## **DFCM Addendum No.#1**

**Reference:** Rampton 1st and 3rd Floor Remodel

Department of Public Safety DFCM Project 24371550

## Addendum #01

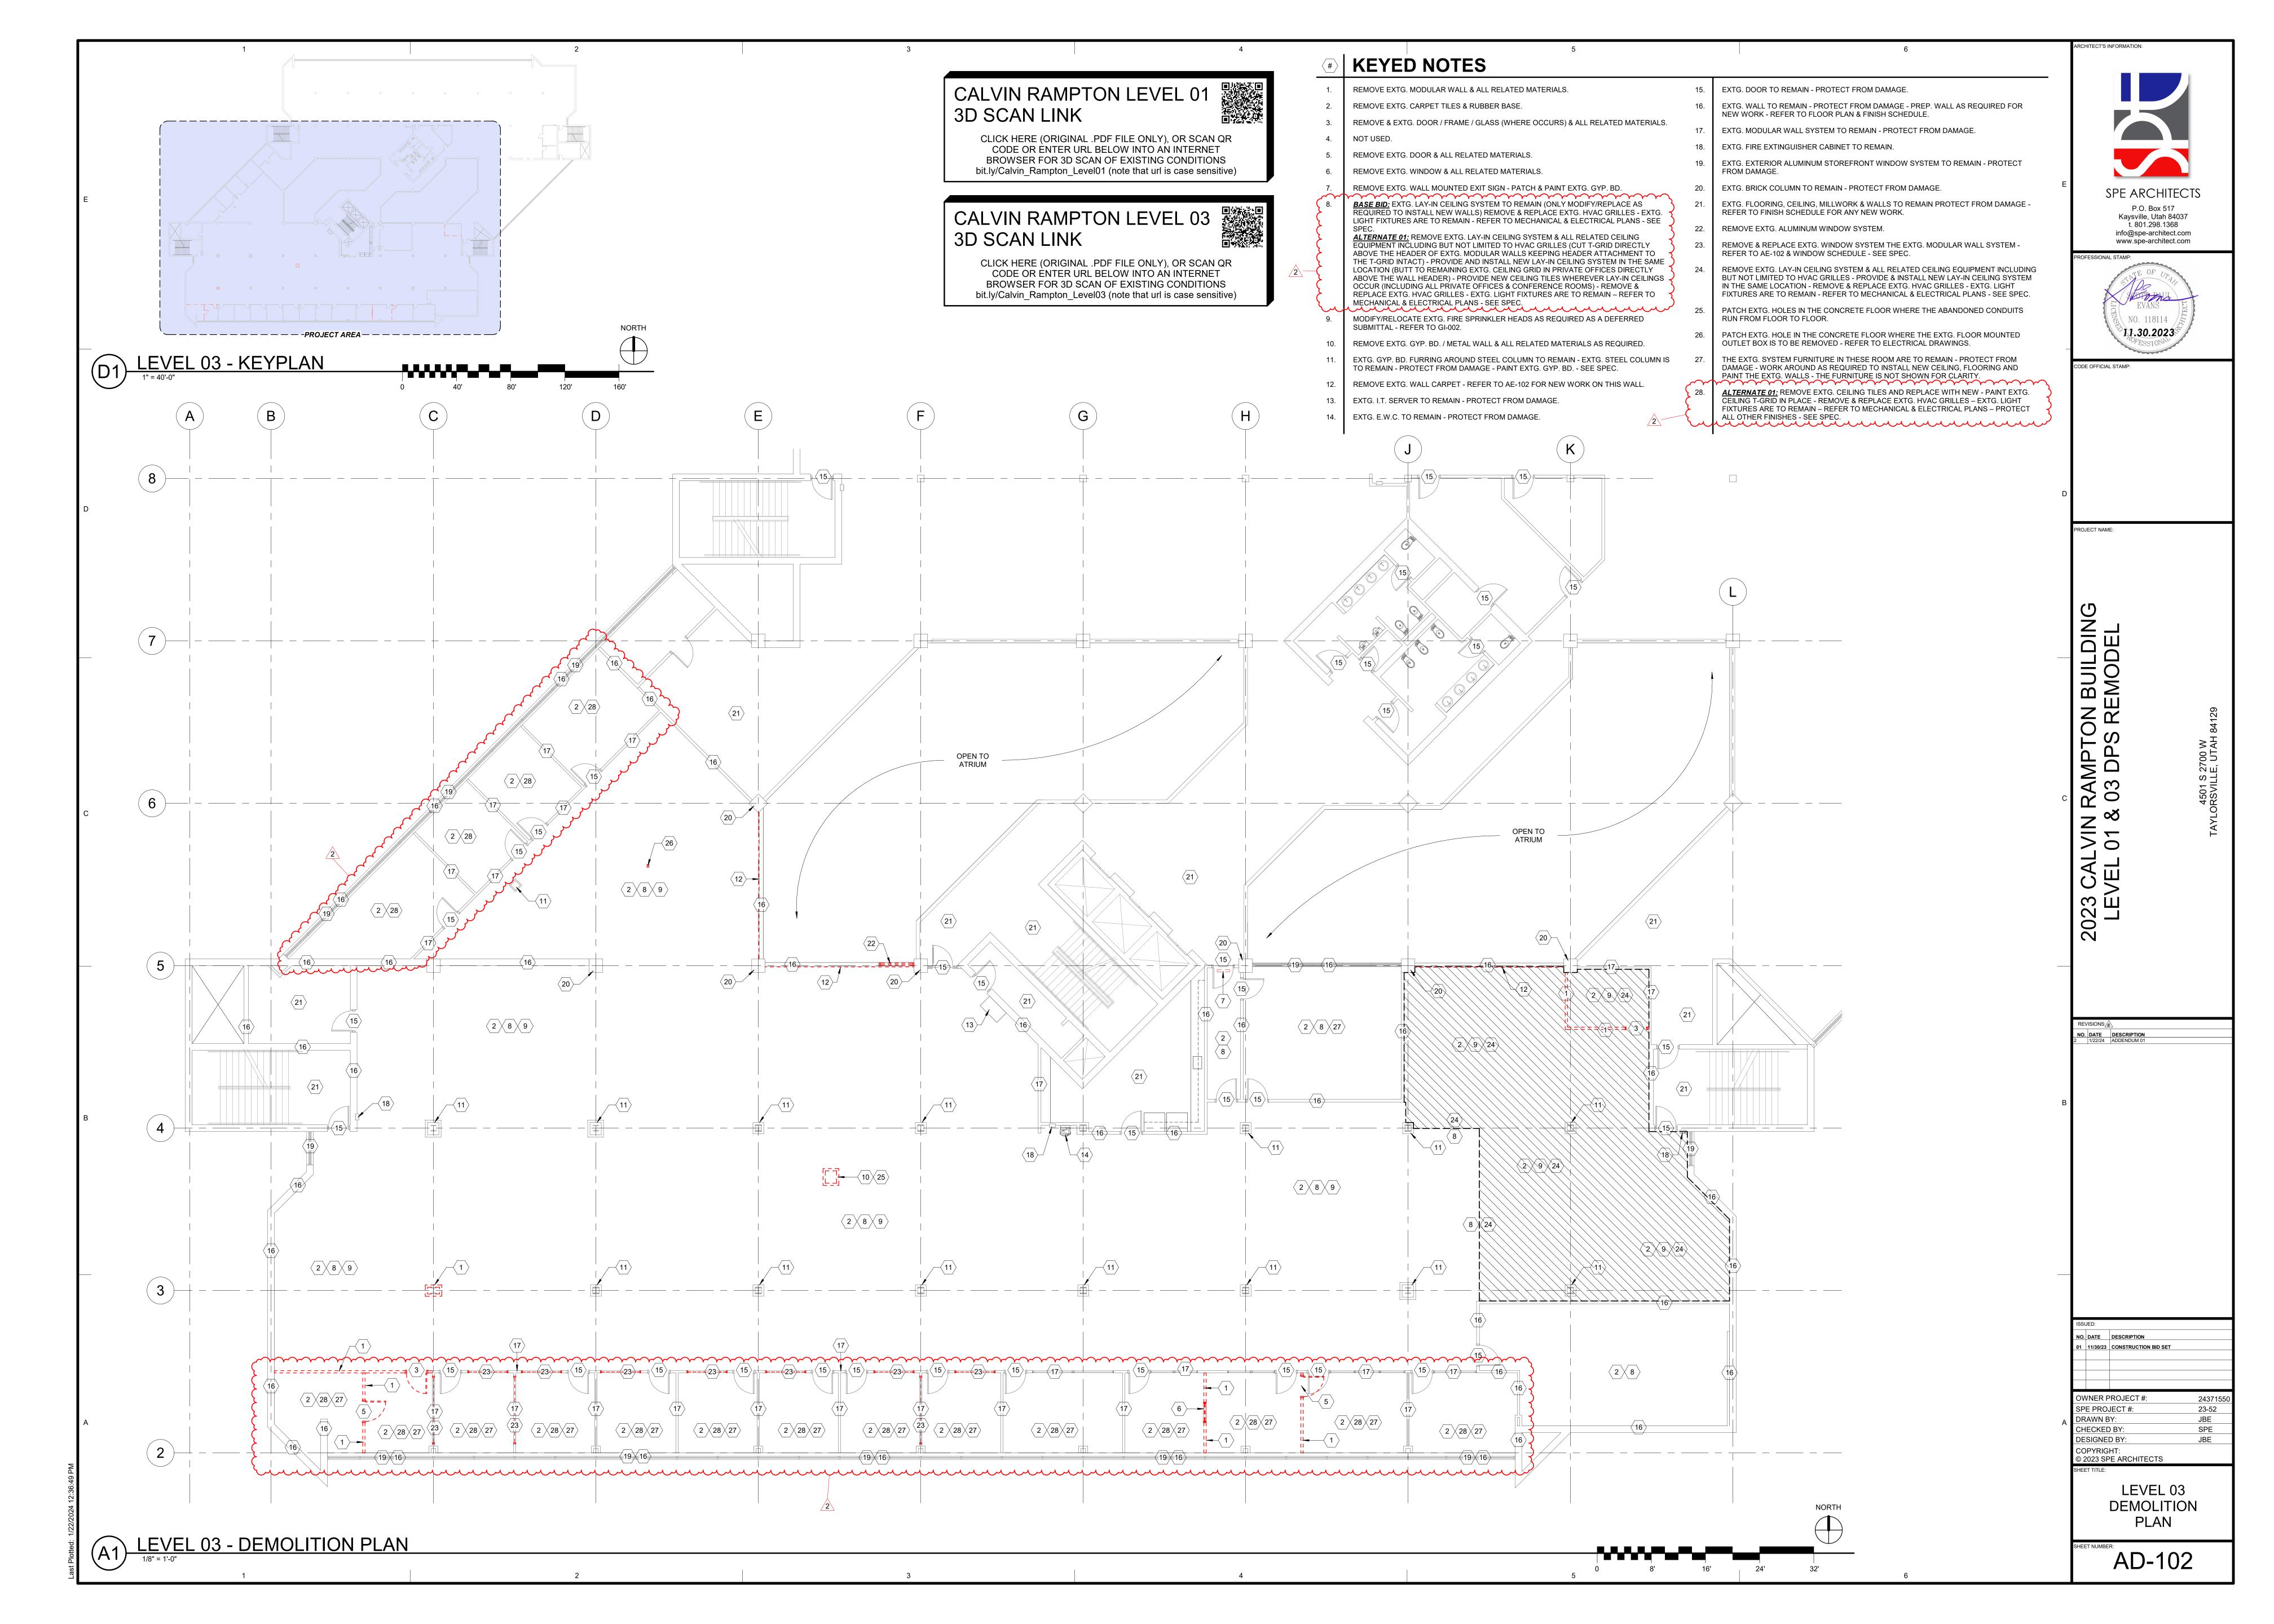
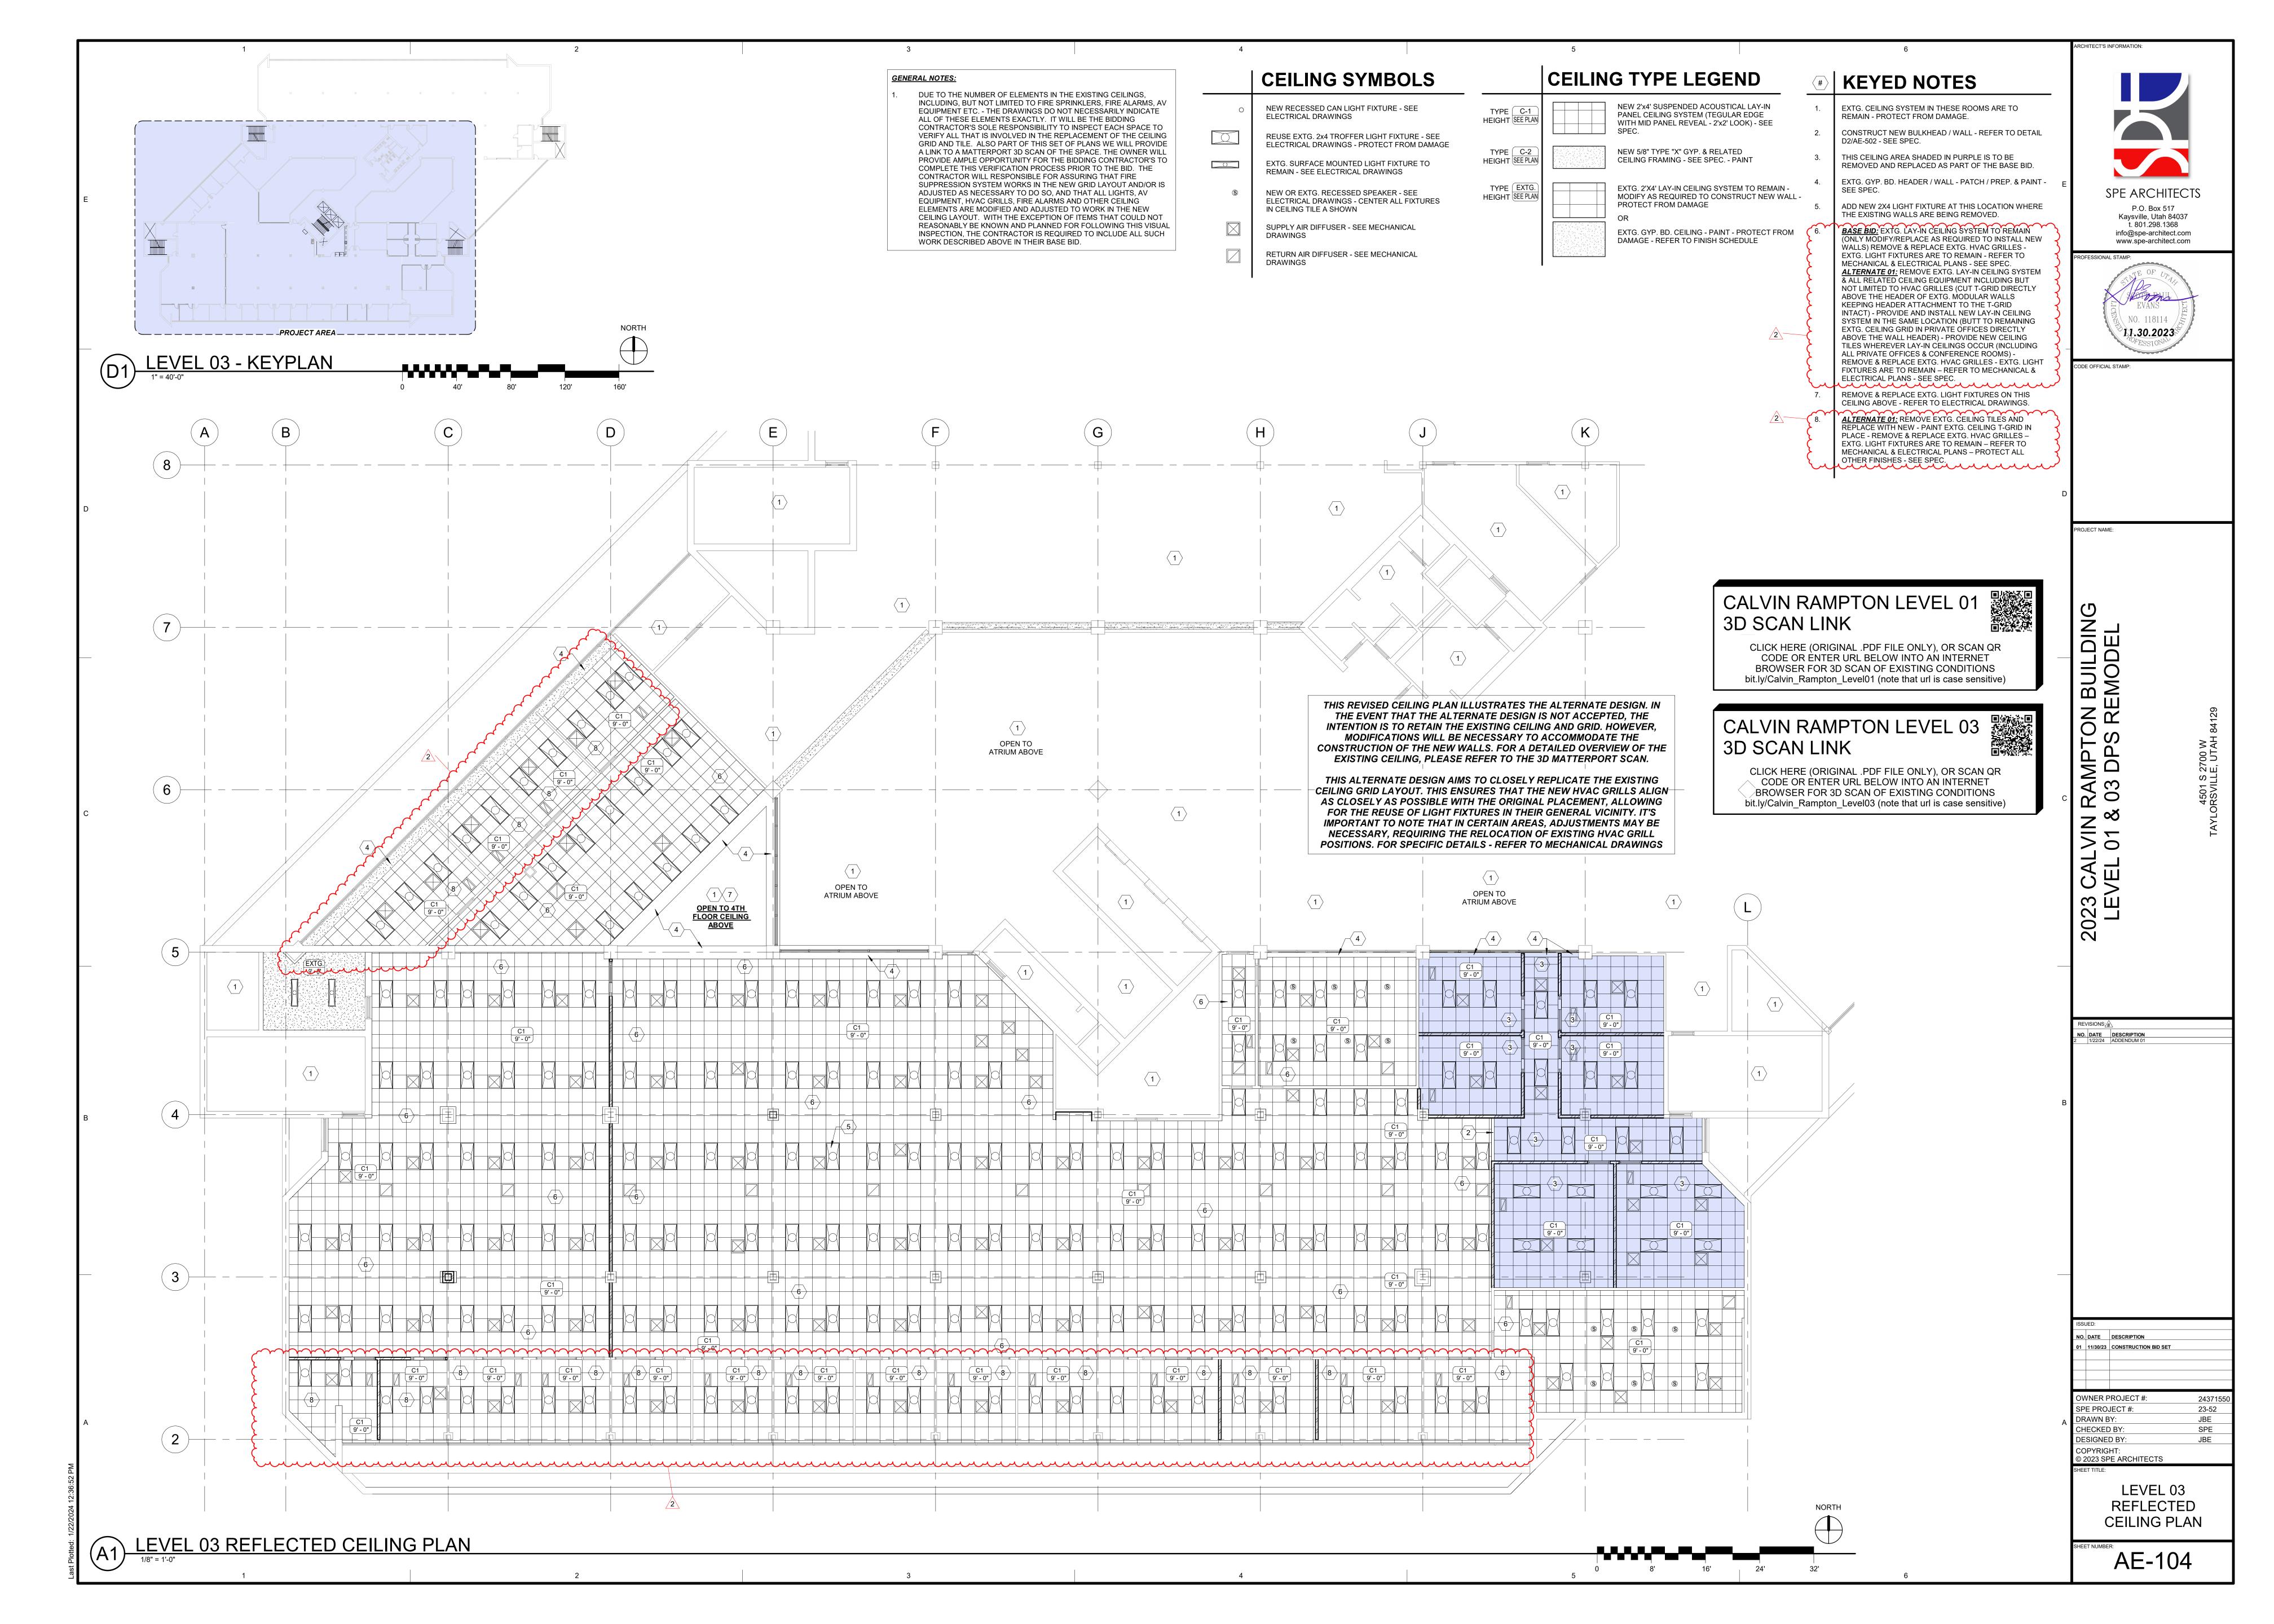
Q: 'Please advise what the wood species is for the door on this project.'

A: It is believed to be White Oak, F.V. and match existing.

EE001

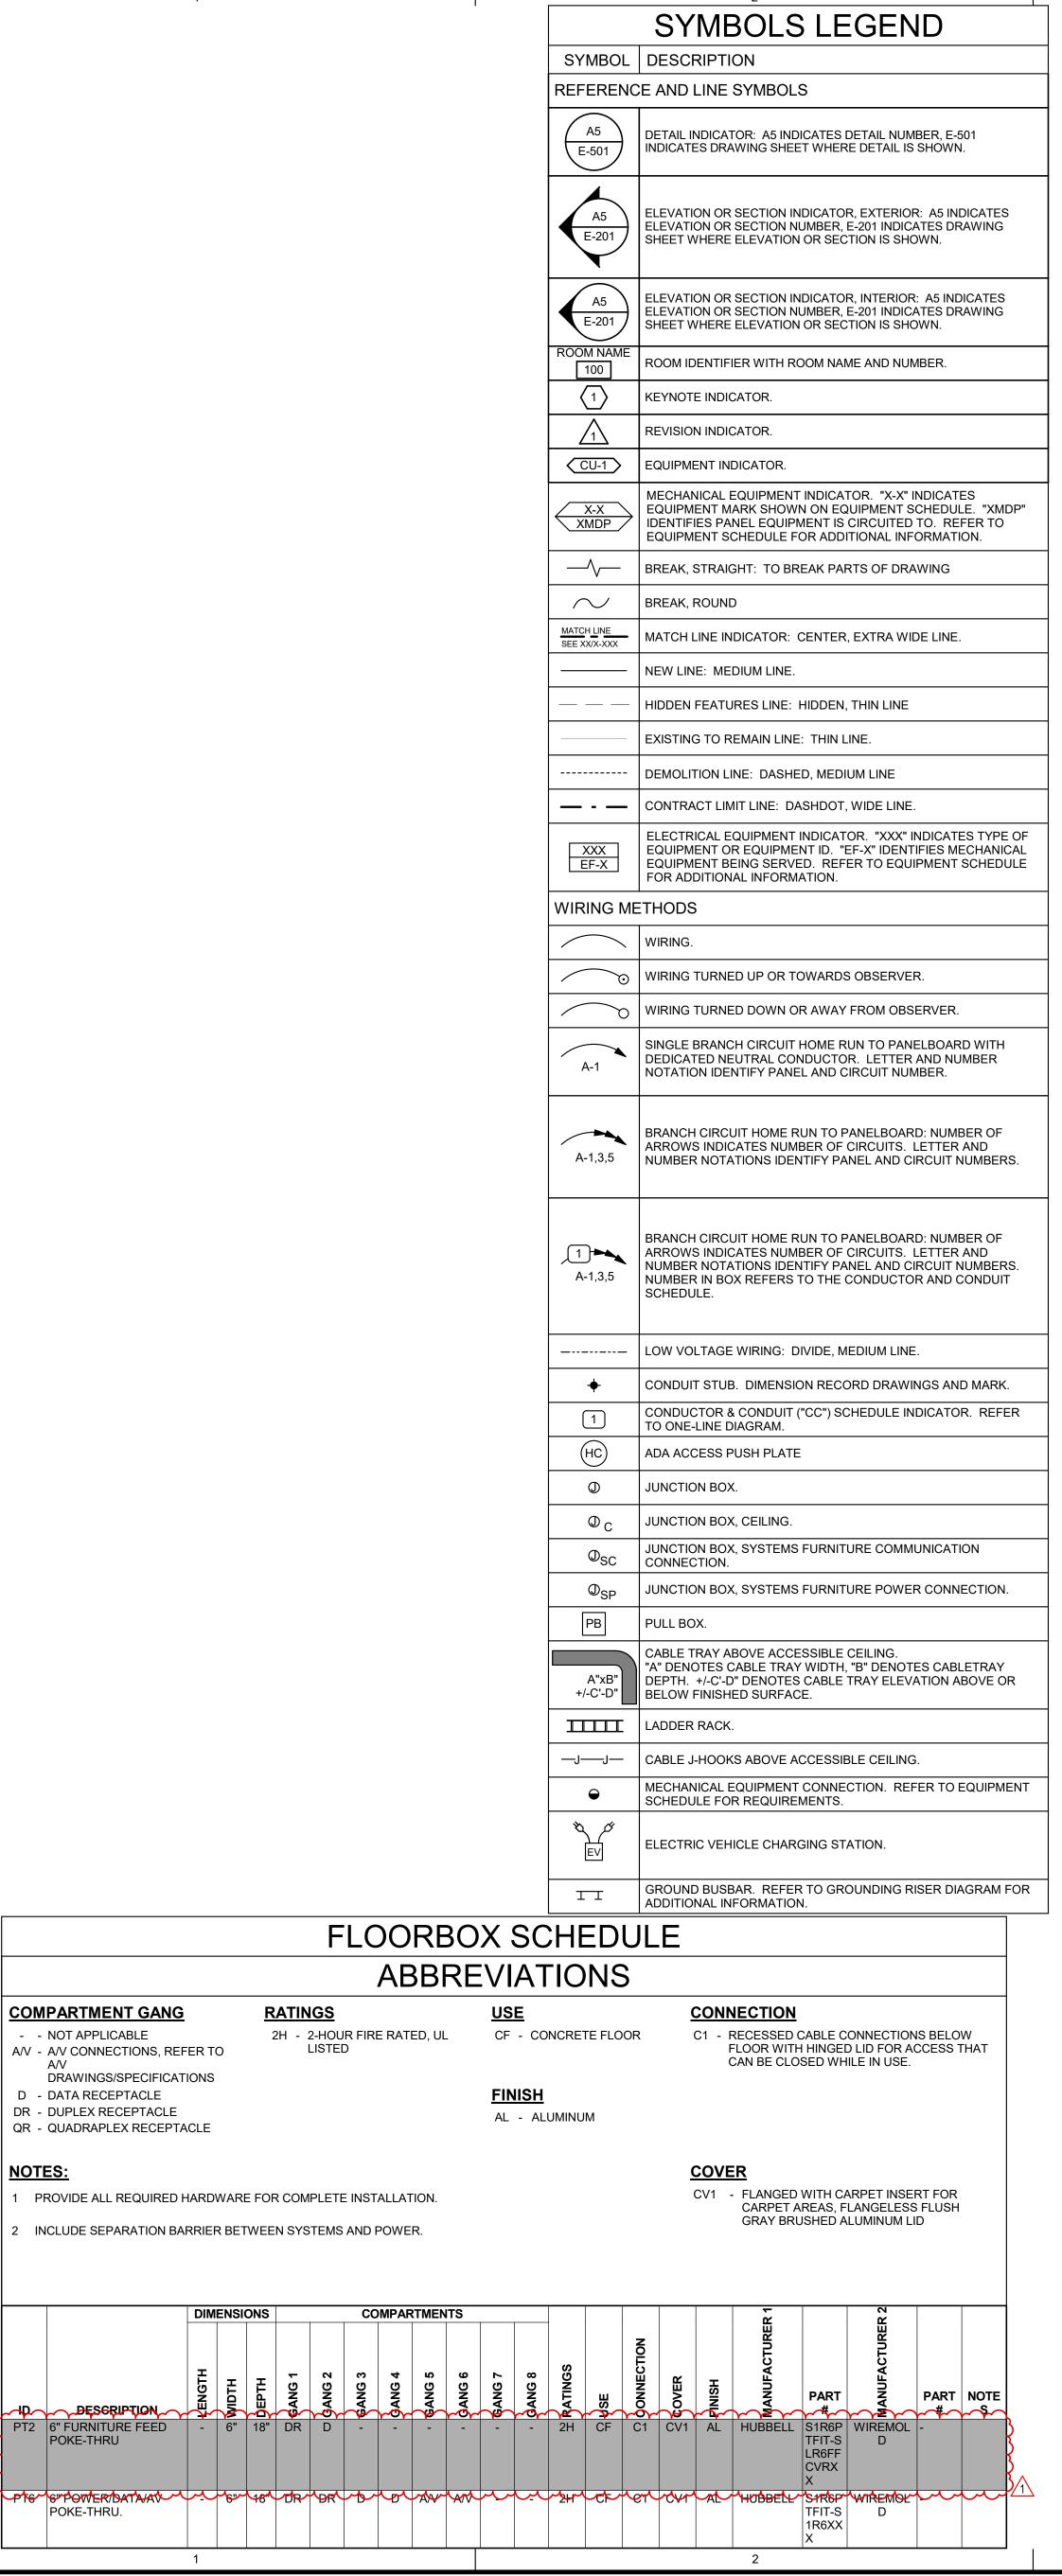
SHEET - EE001

1. Added PT2 to the floorbox schedule.
